DEVIATION REQUEST AND DECISION FORM

Project Name :	Crossroads North
Schedule No.(s) :	5408001008, 5408001029, 5408001032, 5408001033, 5408001034, 5408001041, 5408001042, 5408001050, 5408001051, 5408001052
Legal Description :	LOTS 12, 13, 14, 15, 16 AND 18, HILLCREST ACRES, ACCORDING TO THE PLAT THEREOF RECORDED MAY 12, 1960 AT RECEPTION NO. 153860, EXCEPT THAT PORTION ACQUIRED BY THE DEPARTMENT OF TRANSPORTATION, STATE OF COLORADO AS DESCRIBED IN RULE AND ORDER RECORDED APRIL 28, 2004 UNDER RECEPTION NO. 204068322, AND EXCEPT THOSE PORTIONS CONVEYED TO EL PASO COUNTY BY AND THROUGH THE BOARD OF COUNTY COMMISSIONERS OF EL PASO COUNTY, COLORADO BY SPECIAL WARRANTY DEED RECORDED DECEMBER 17, 2014 AT RECEPTION NO. 214116021 AND RECORDED DECEMBER 17, 2014 AT RECEPTION NO. 214116022, COUNTY OF EL PASO, STATE OF COLORADO. LOT 17, HILLCREST ACRES, COUNTY OF EL PASO, STATE OF COLORADO, EXCEPT THAT PORTION CONVEYED TO EL PASO COUNTY BY AND THROUGH THE BOARD OF COUNTY COMMISSIONERS OF EL PASO COUNTY, COLORADO BY SPECIAL WARRANTY DEED RECORDED DECEMBER 30, 2014 AT RECEPTION NO. 214119767. LOT 19, HILLCREST ACRES, COUNTY OF EL PASO, STATE OF COLORADO, AS AMENDED BY SURVEYOR'S STATEMENT RECORDE

SCALE: NOT TO SCALE

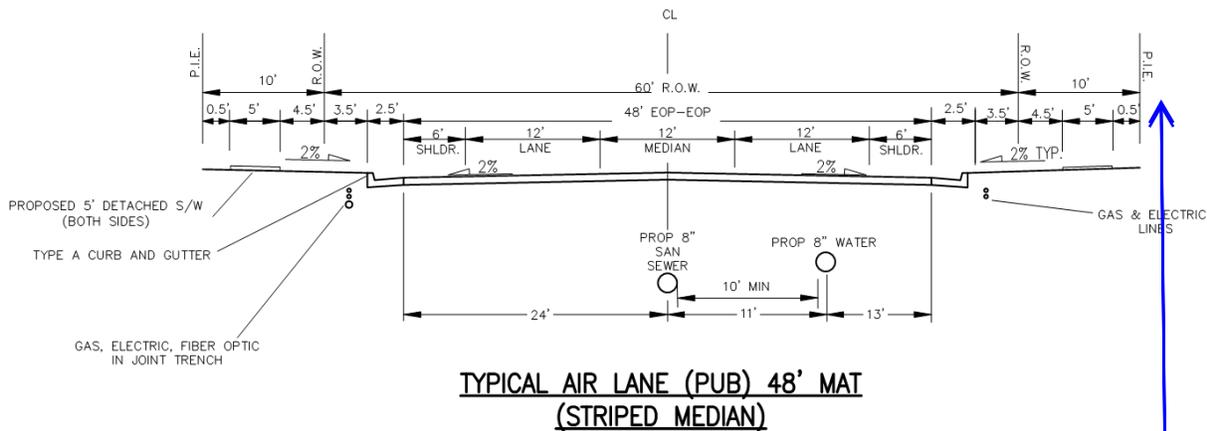
Provide documentation that this P.I.E exist along the southside of Air Lane. If it doesn't then the development would need to acquire the necessary easement from the property before the deviation request would be approved.

Unresolved from review 3.

Plat 1950 (attached) for Hillcrest Acres subdivision does not show this easement.
Unresolved.
